MAWSS/MUNICIPAL PARK SUBDIVISION

APPLICATION NUMBER 3 DATE August 5, 2021

REQUEST Subdivision

DETAIL SITE PLAN

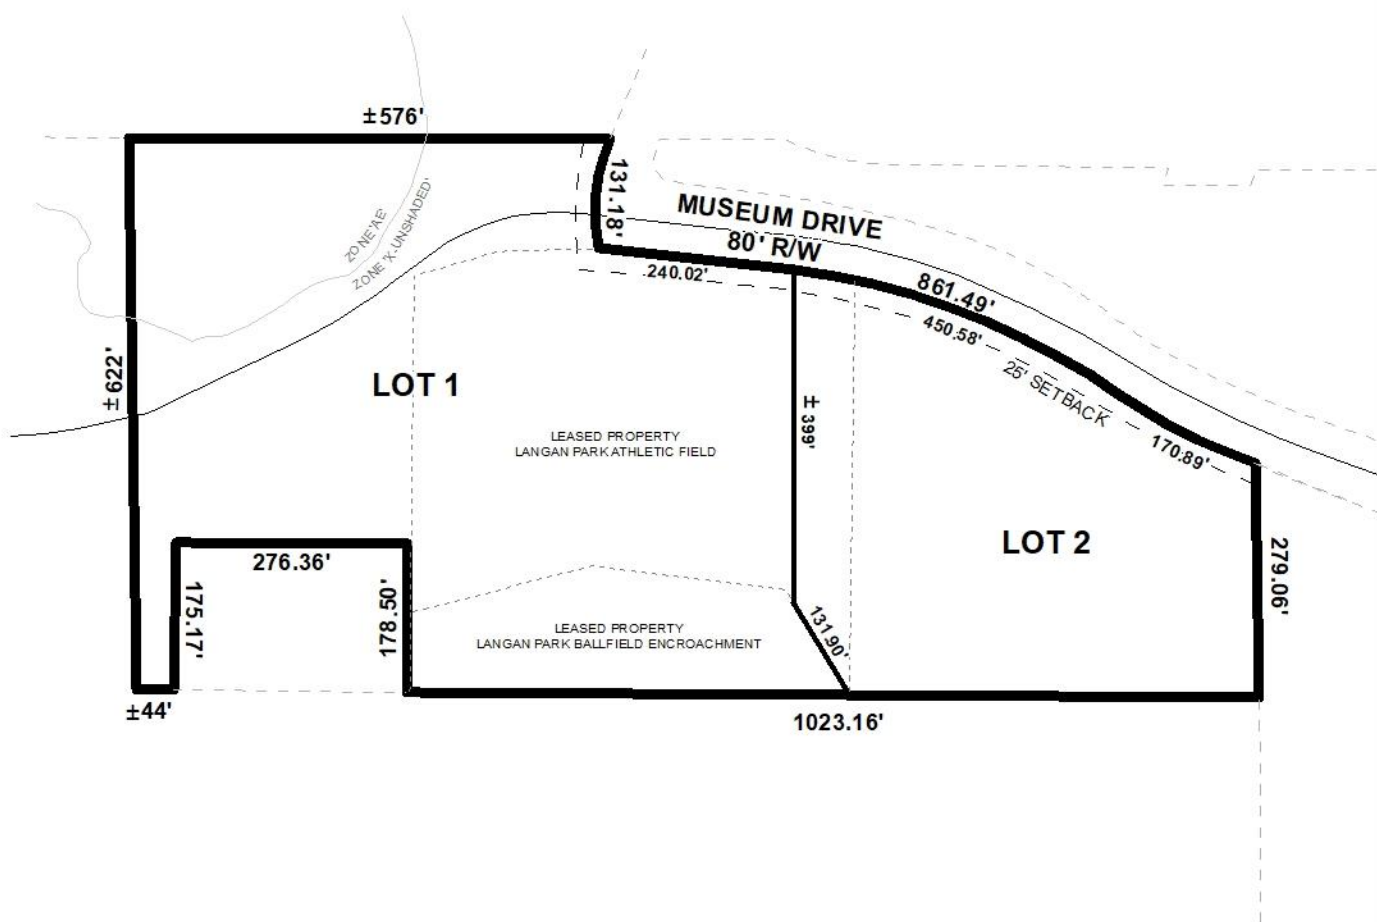
- B. Add legible street names to the vicinity map.
- C. National Wetlands Inventory (NWI) mapping, as shown on City of Mobile GIS information, indicates that there is potential for wetlands within the property or properties shown on this plat. Show and label the delineated wetlands, or provide a note stating that the wetlands shown on this plat are scaled from the NWI data and have not been delineated.

- D. Provide a note that a 25' riparian buffer may be required, during development, along the edge of anything considered by ADEM to be a water of the state.

- E. Show and label the MFFE (Minimum Finished Floor Elevation) on each lot that contains an AE, V, or X (shaded) flood zone designation. BFE = 82.0.
- F. Show and label each and every Right-Of-Way and easement including that portion of Museum Drive.

- G. Provide the Surveyor's and Owner's (notarized) signatures.
- H. Add a note to the SUBDIVISION PLAT stating that as shown on the 1984 aerial photo (FLIGHT 22 - #78) LOTS 1 and 2 will receive historical credit of existing (1984) impervious area towards stormwater detention requirement per Mobile City Code, Chapter 17, Storm Water Management and Flood Control) as follows: LOT 1 – 3,900 sf and LOT 2 – NONE. The existing Museum Drive (and cul-de-sac) pavement are not included in the amount allowed for LOT 1.

The 25' minimum building setback is shown along the public street portion of Museum Drive, and should be retained on the Final Plat, if approved.

The proposed lot sizes are provided in square feet and acres on the preliminary plat. If approved, this information should be retained on the Final Plat.

No easements are indicated on the preliminary plat. If any easements are recorded on the site they should be indicated and labeled on the Final Plat, and a note should be placed on the Final Plat stating that no structure may be placed or constructed within any easement without permission of the easement holder.

- 1) Retention of the 25-foot minimum building setback line along the public portion of Museum Drive;
- 2) Retention of the current right-of-way for Museum Drive;
- 3) Retention of the lot size in both square feet and acres, or the furnishing of a table on the Final Plat providing the same information;
- 4) Placement of a note on the Final Plat stating that no structure may be constructed or placed within any easement without the permission of the easement holder, if applicable;
